# Access Compliance Report

## Public Rights-of-Way

### (Curb Ramps)

Intersection ID: 46687	Main Street: AYERS_ORCHARD_WY	Cross Street: TROTTERS_RIDGE_RD	Location: SW
ADA ID: 025E789BD73D	Ramp Type: PerpDiag	Initial Pass/Fail: Fail	Overall Compliance: No
Severity Score: 22.5			
Codes/Mitigation Info/Possible Solution		Field Measurements/Component Compliance

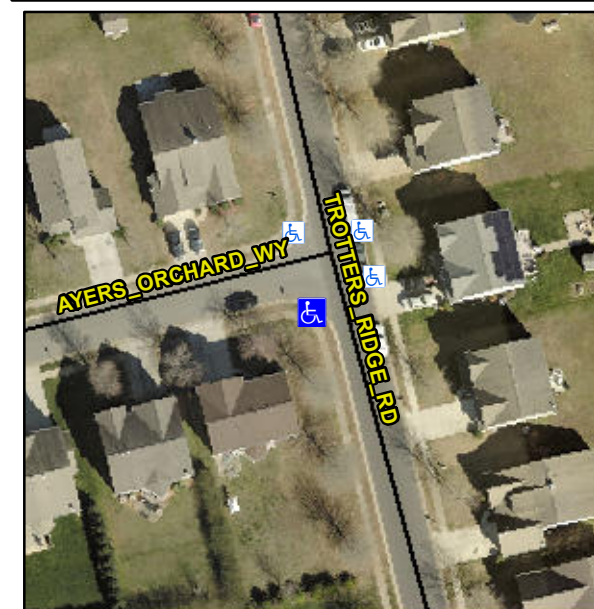
**Not Found, R304.5.1, R304.2.2, R304.5.3**

Compliance	Description	Data	Compliance	Description	Data
N/A	Ramp Length (in)	47.0	No	Ramp Slope (%)	9.3
No	Ramp Width (in)	47.5	No	Ramp XSlope (%)	2.5
N/A	Flare Type LT	N/A	N/A	Flare Type RT	N/A
N/A	Flare Slope LT (%)	N/A	N/A	Flare Slope RT (%)	N/A
N/A	Flare Traversable LT?	N/A	N/A	Flare Traversable RT?	N/A
N/A	Landing Length (in)	N/A	N/A	DWS Provided?	N/A
N/A	Landing Width (in)	N/A	N/A	DWS Contrast?	N/A
N/A	Landing Slope (%)	N/A	N/A	DWS Length (in)	N/A
N/A	Landing X Slope (%)	N/A	N/A	DWS Full Width?	N/A
N/A	Landing Curb? (Y/N)	N/A	N/A	DWS Offset (in)	N/A
N/A	Shared Landing?	N/A			
N/A	Gutter Ponding?	N/A	N/A	Gutter Slope (%)	N/A
N/A	Gutter Lip Ht (in)	N/A	N/A	Gutter X Slope (%)	N/A
N/A	Painted X Walk1?	No	N/A	Painted X Walk2?	No
	X Walk 1 Direction	To E		X Walk 2 Direction	To N
N/A	X Walk 1 Width (in)	N/A	N/A	X Walk 2 Width (in)	N/A
	X Walk 1 Slope (%)	0.9		X Walk 2 Slope (%)	0.3
	X Walk 1 X Slope (%)	0.2		X Walk 2 X Slope (%)	2.3

**Remove & Replace Curb Ramp With Two New Directional Ramps or Equivalent.**
